# UNITED STATES PATENT AND TRADEMARK OFFICE

APPLICATION NO.	FILING DATE	FIRST NAMED INVENTOR	ATTORNEY DOCKET NO.	CONFIRMATION NO.
10/771,522	02/05/2004	Junpei Ogawa	023971-0371	3059

# Office Action Summary

# **ATTACHMENT**

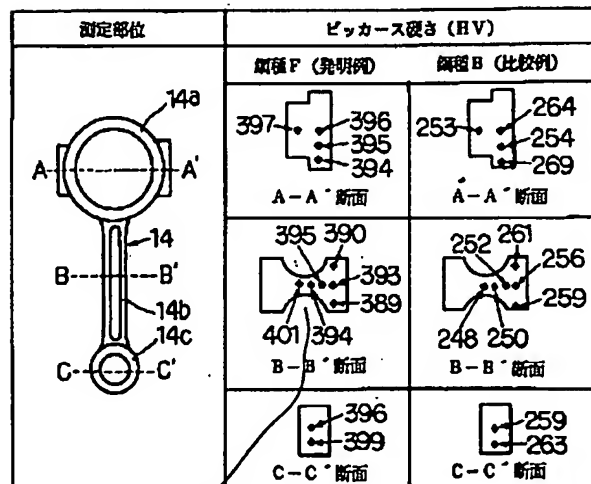
- a connecting beam section (at 14b in Fig. 11(D). See Attachment) serving as a main body of the connecting rod;

- a first joining section (Att.) located between the connecting beam section (Att.) and the big end 12a, 13a, 14a to connect the connecting beam section (Att.) and the big end 12a, 13a, 14a; and

- a second joining section (Att.) located between the connecting beam section (Att.) and the small end 12c, 13c, 14c to connect the connecting beam section (Att.) and the small end 12c, 13c, 14c;

wherein each of the first and second joining sections (Att.) gradually and continuously decreases in cross sectional area toward the connecting beam section (Fig. 12) and has a strength distribution in which a strength increases with a decrease in the cross sectional area.
